Subject: OPERATIONAL CONCERNS WHEN PLAYING A MEDIA DEVICE (IPOD, USB MEMORY STICK, ETC.) CONNECTED VIA USB	Bulletin No: 09-008/15
	Last Issued: 02/23/2015

2013 Mazda3

2013-15 CX-5

2014-15 Mazda6

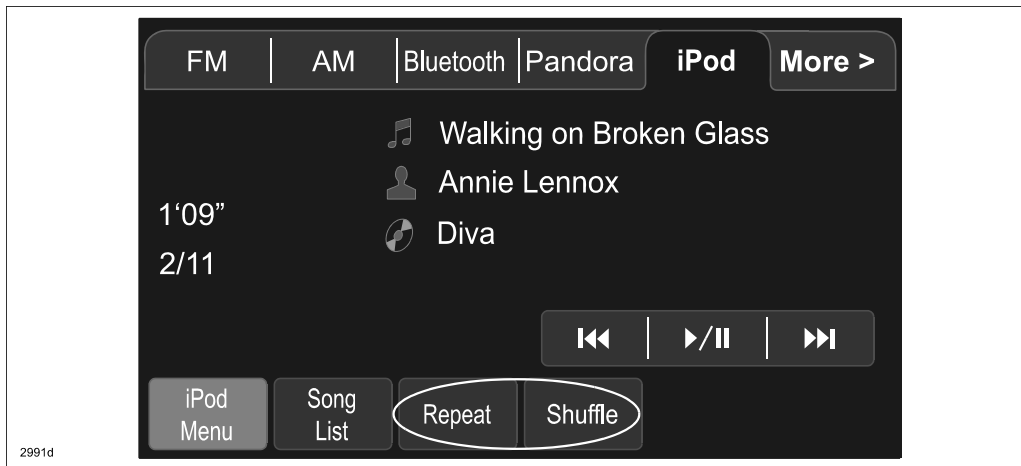
1. Playback will start with the song that was last playing in the vehicle, even if the device was playing a different track outside the vehicle.
2. After the ignition is turned ON, the screen will display “1/1” instead of “1/12” (for example). “1/1” will continuously be displayed until loading is completed.

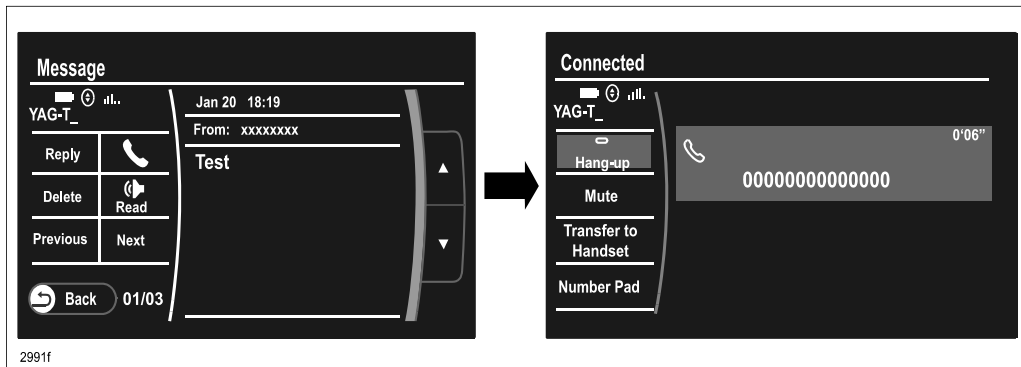
- "SMS/Text - Receive Message" and "SMS/Text - Notification" are now available. The other functions are still not available as before.

- ✓ SMS/Text - Receive Message
- ✗ SMS/Text - Send Message
- ✓ SMS/Text - Notification
- ✗ Email - Receive Message
- ✗ Email - Send Message
- ✗ Email - Notification

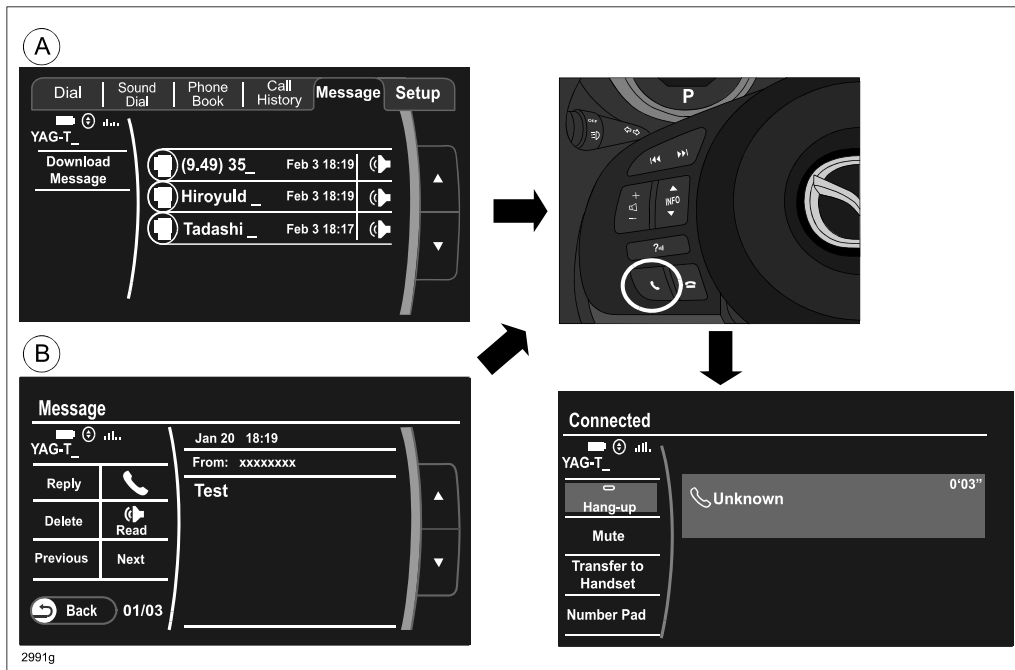
- **When a SMS is received from a telephone number registered in the contact list:**
 - Calls cannot be made by pushing the “Receiver” button. “000000000000” is displayed on the screen.

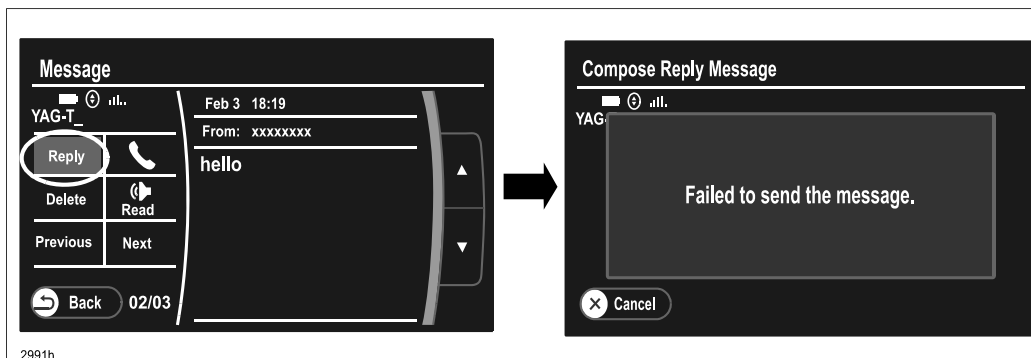
- Calls cannot be made even if you touch the “Speaker” button on the “Message” screen (A) or the “MessageRead” screen (B) and then push the pick-up button during VoicePrompt. No telephone number (Unknown) is displayed on the “Calling” screen.

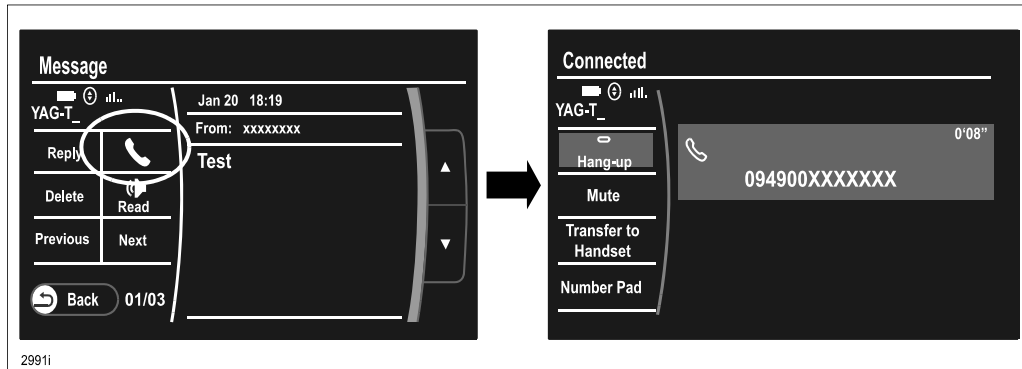
- The “Reply” button on the “Message” screen cannot be used (does not function).
